PLAN OF PROPOSED IMPROVEMENT

NINTH ADDITION TO BLACKHAWK SUBDIVISION - PLAT AND REZONE

CITY PROJECT NO. 11943

TYPICAL FINISHED SECTION
SANDHILL ROAD
STA 100+31.28 TO STA 104+63.78

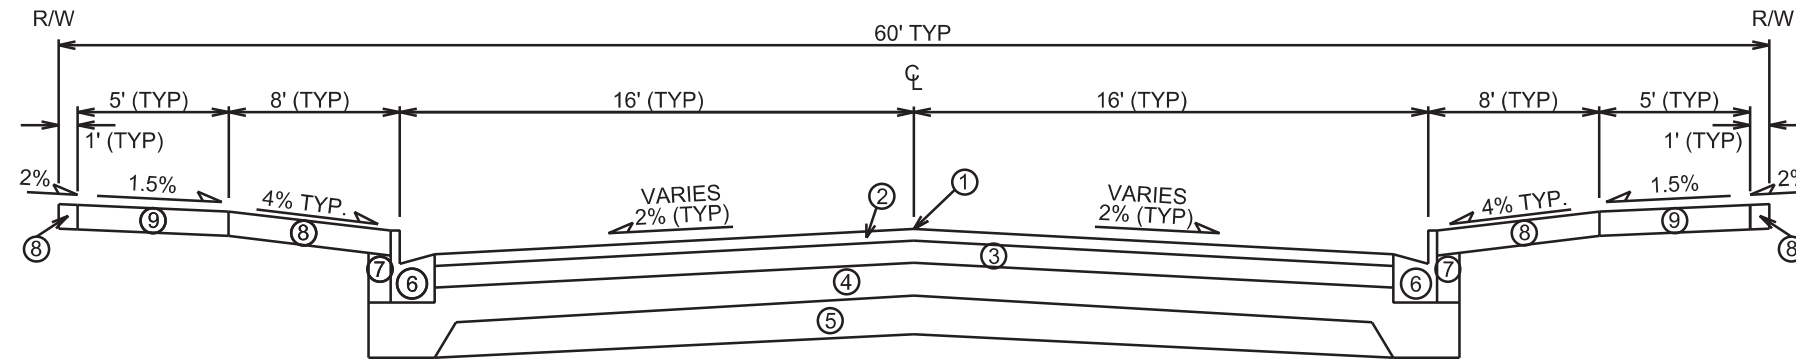
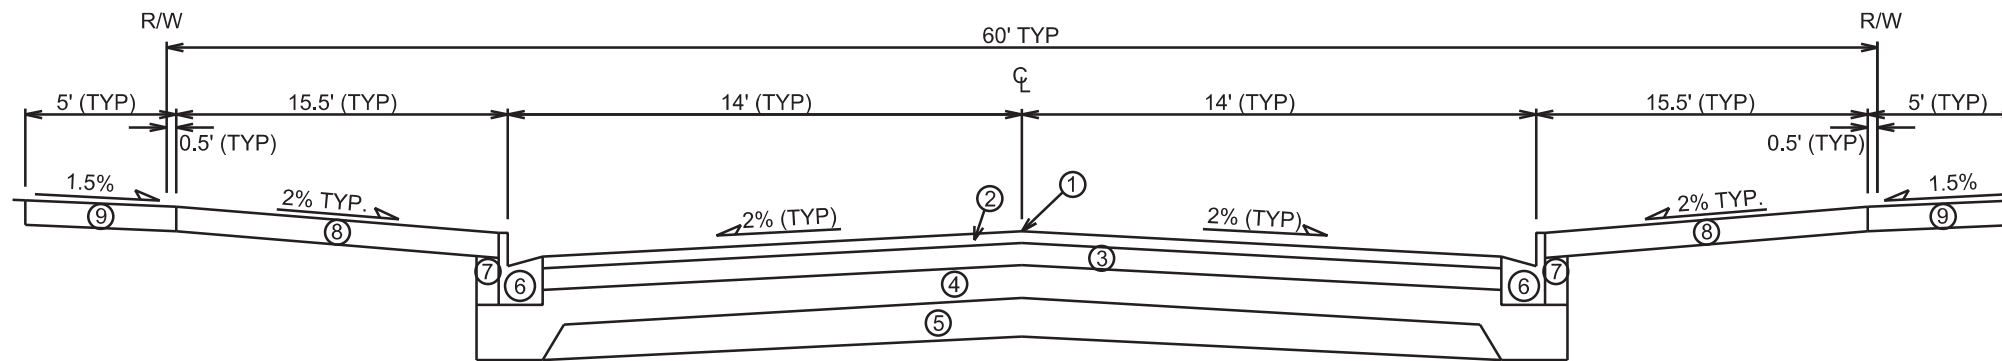
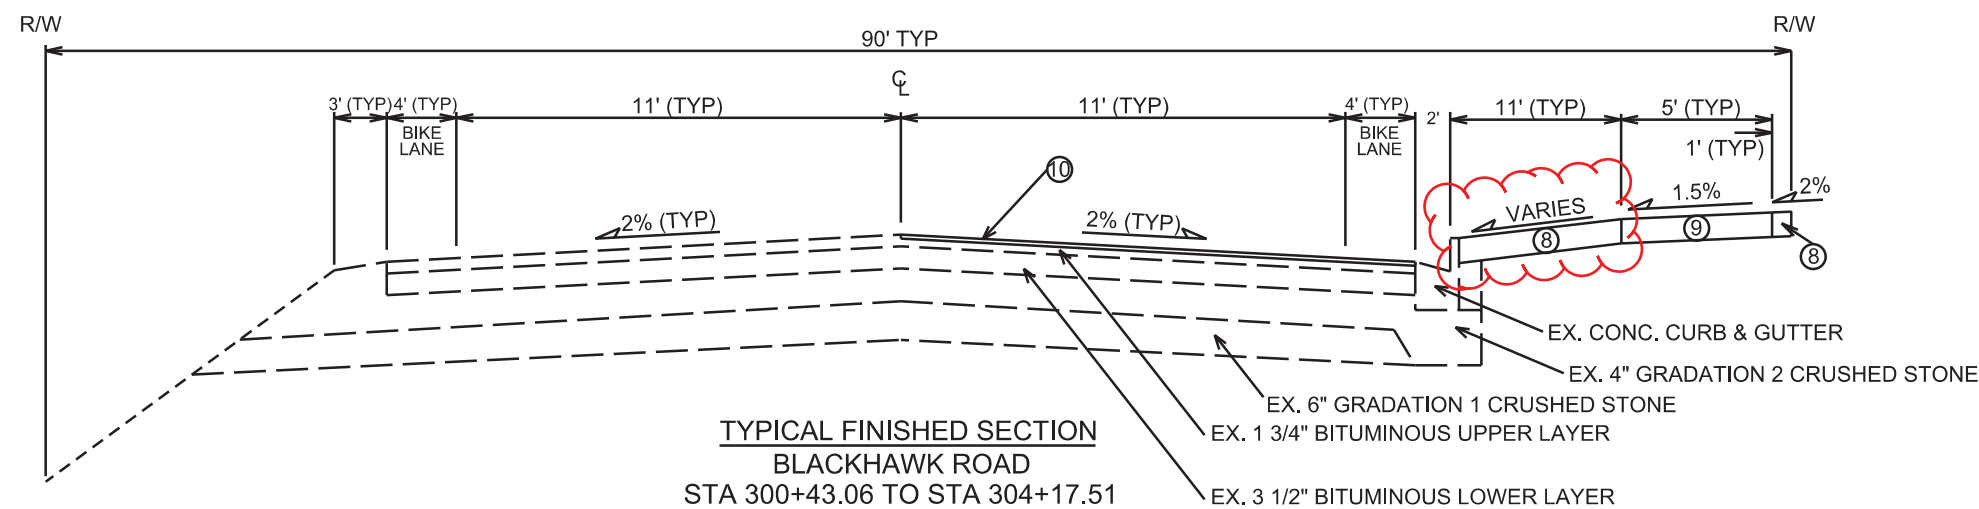
Revised 11-15-2018 AJZ
-revise terrace slope

SCALE: AS SHOWN
DATE: 10/23/2018
DRAFTER: AMEA
CHECKED: RKOL
PROJECT NO.: 170269
SHEET: 1 OF 3
DWG. NO.: SWM-1

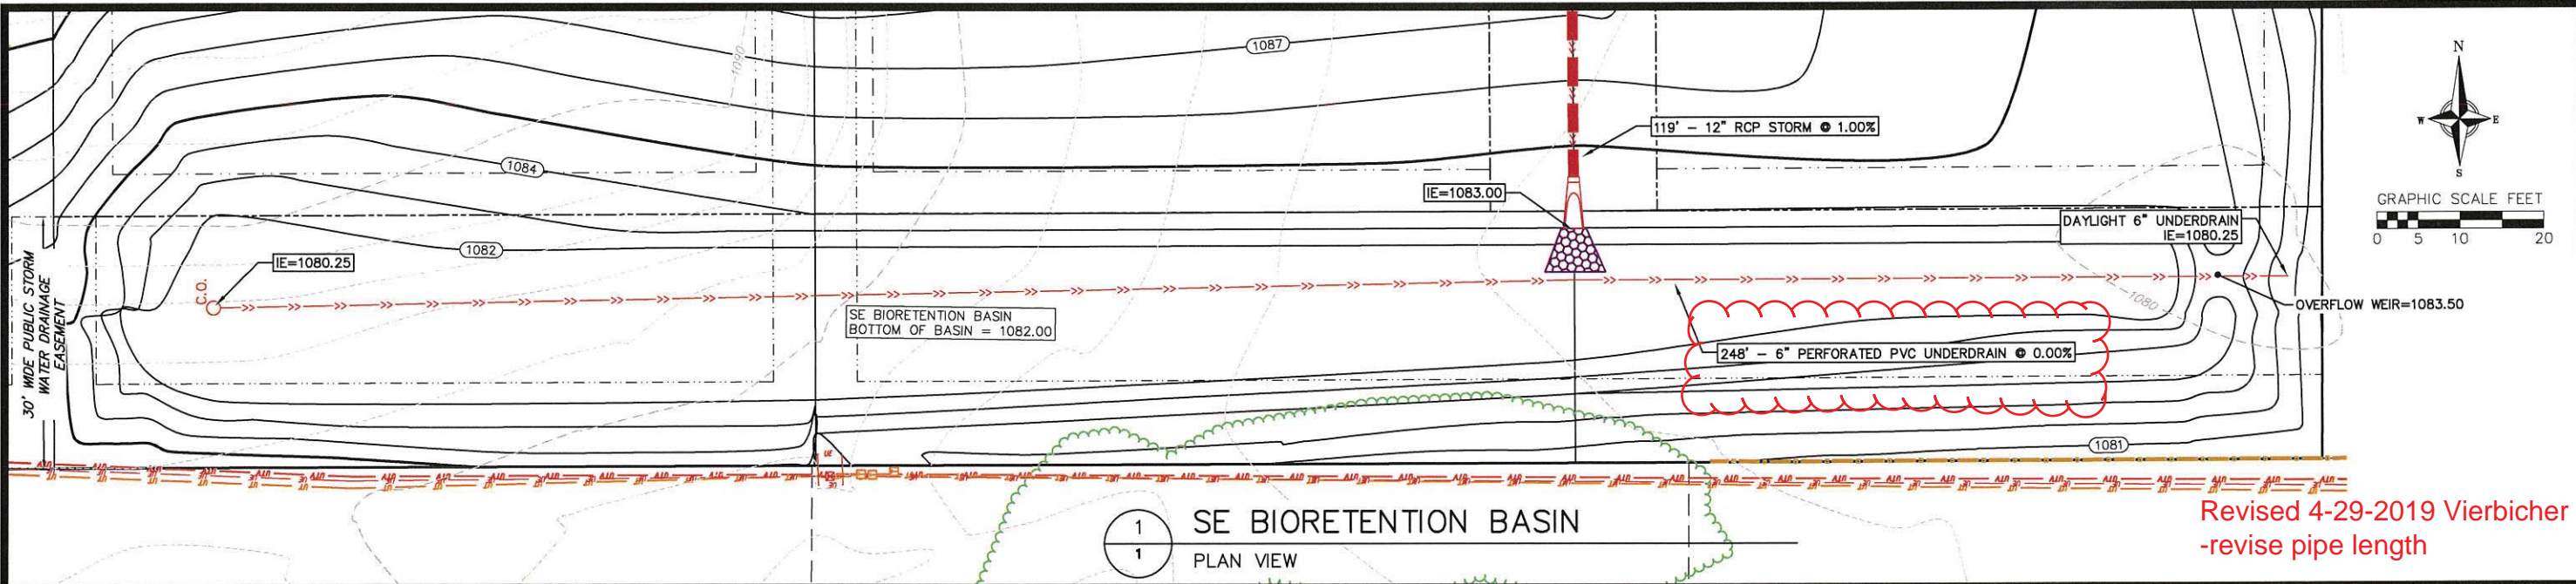
Revised 4-29-2019 Vierbicher
-revise concrete flumes & rain
gardens

DWG. NO. SWM-2

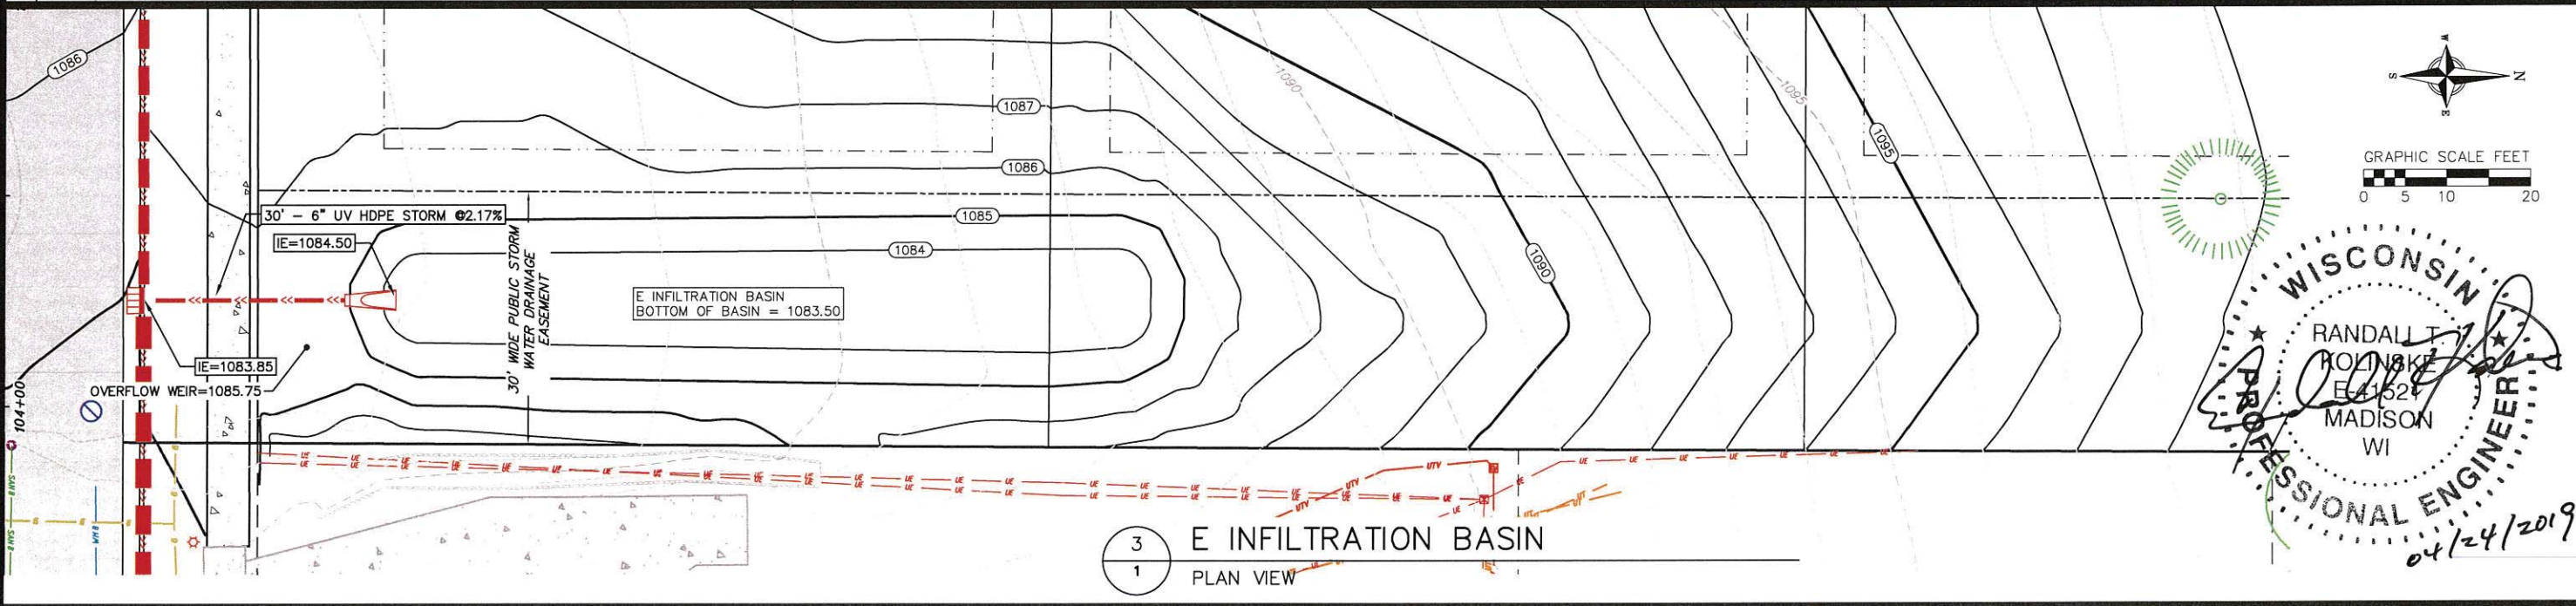
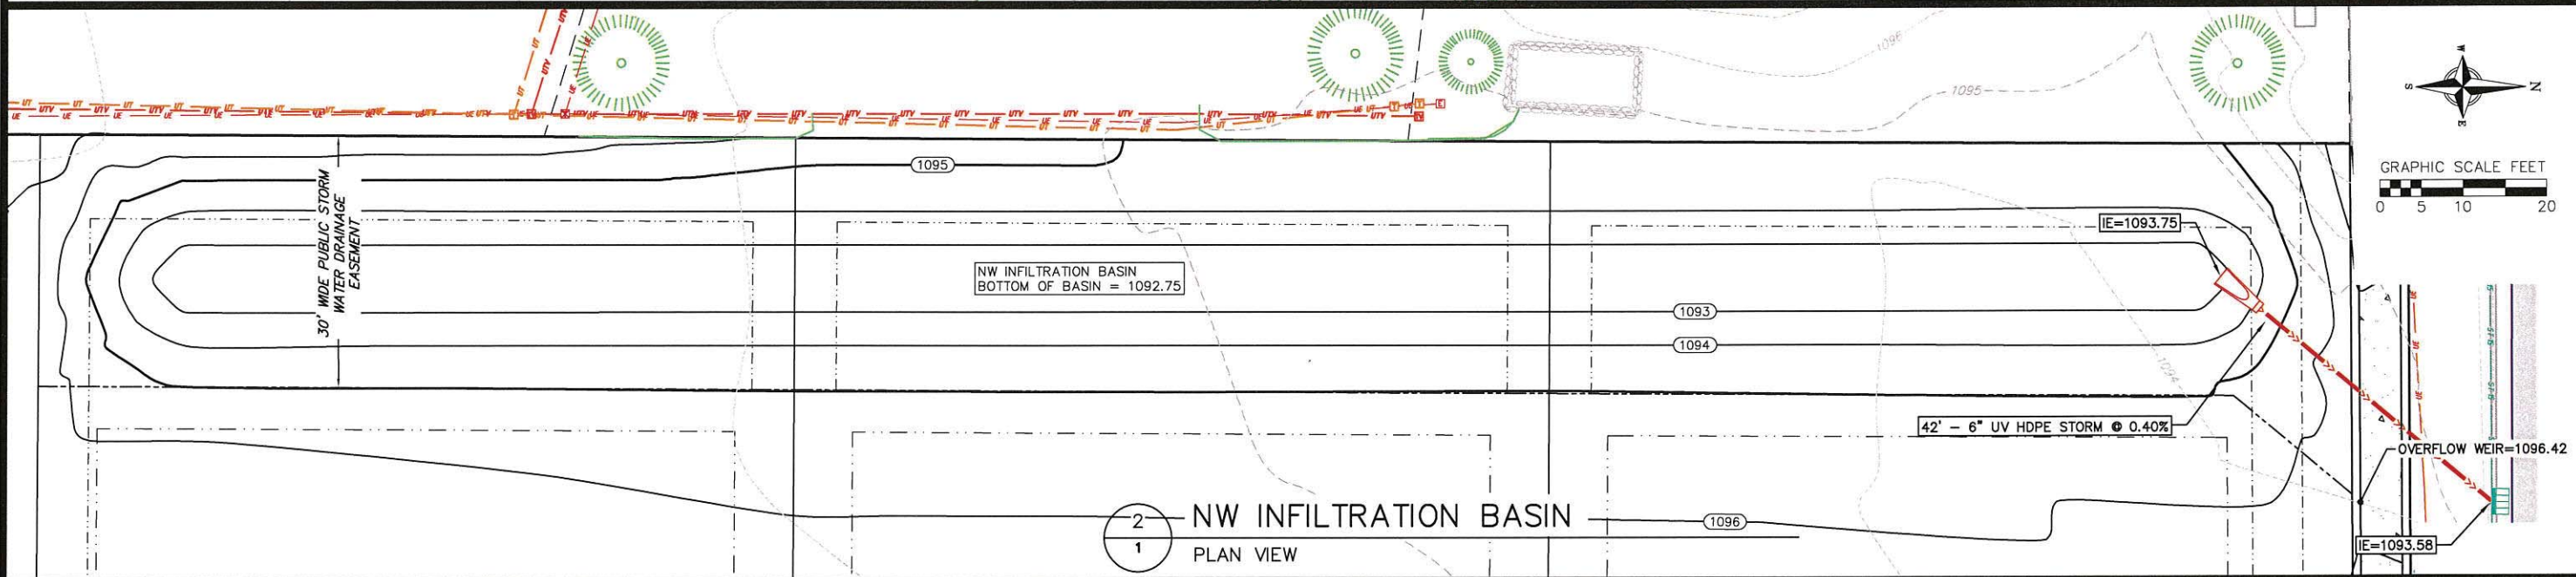
Revised 4-29-2019 Vierbicher
-revise pipe length

SCALE: AS SHOWN
DATE: 10/23/2018
DRAFTER: AMEA
CHECKED: RKOL
PROJECT NO.: 170269
SHEET: 3 OF 3
DWG. NO.: SWM-3

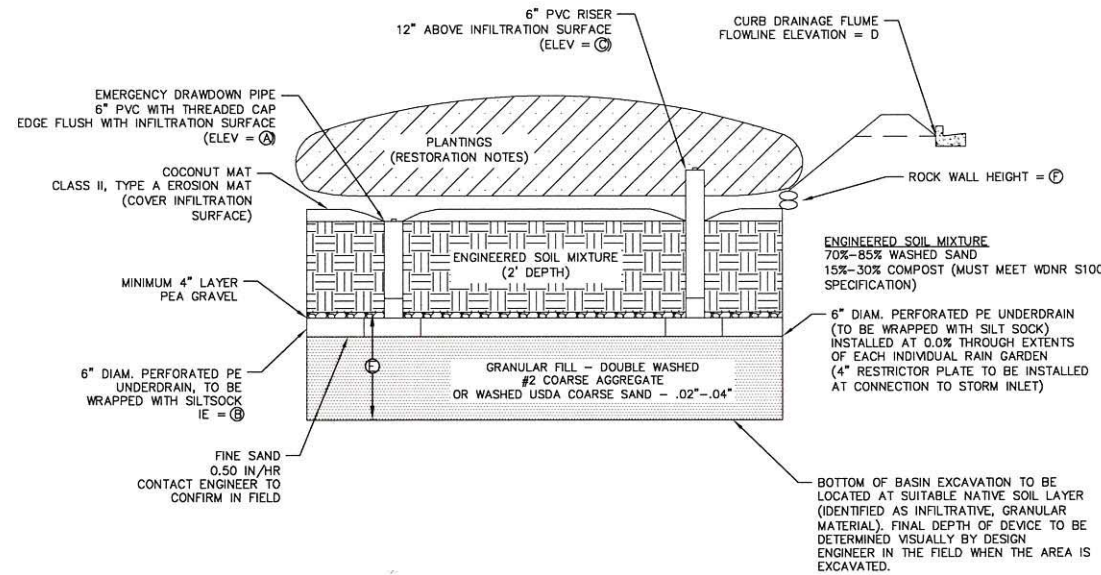
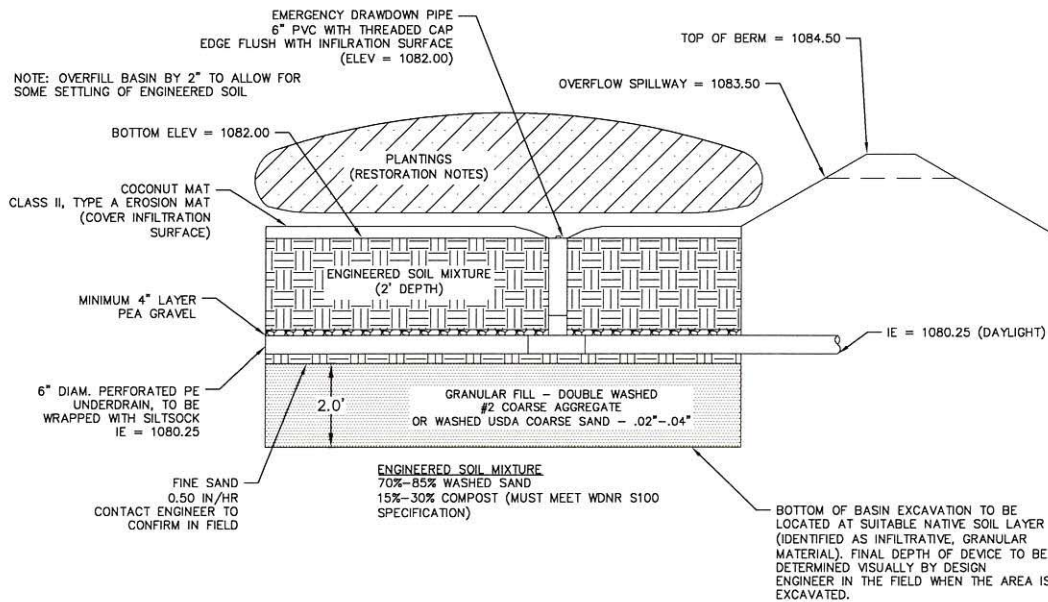
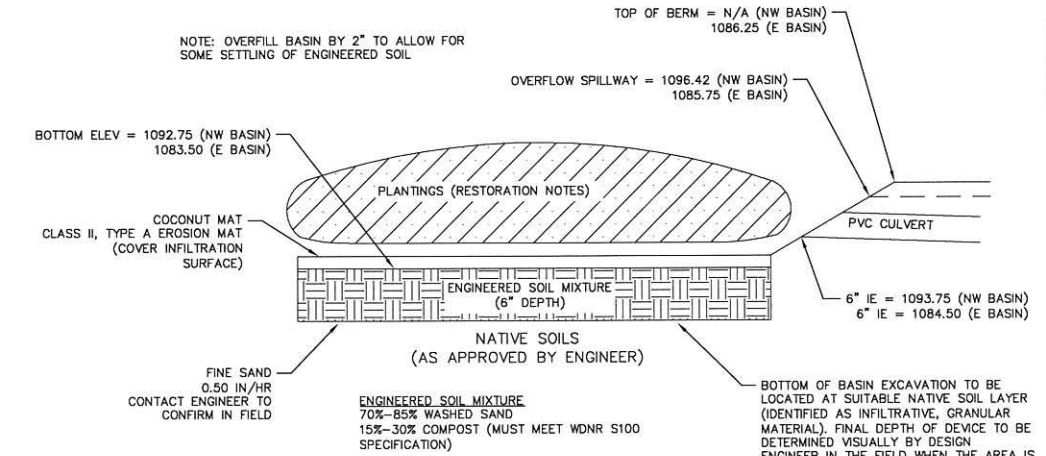
Revised 4-29-2019 Vierbicher
-revise rain garden table
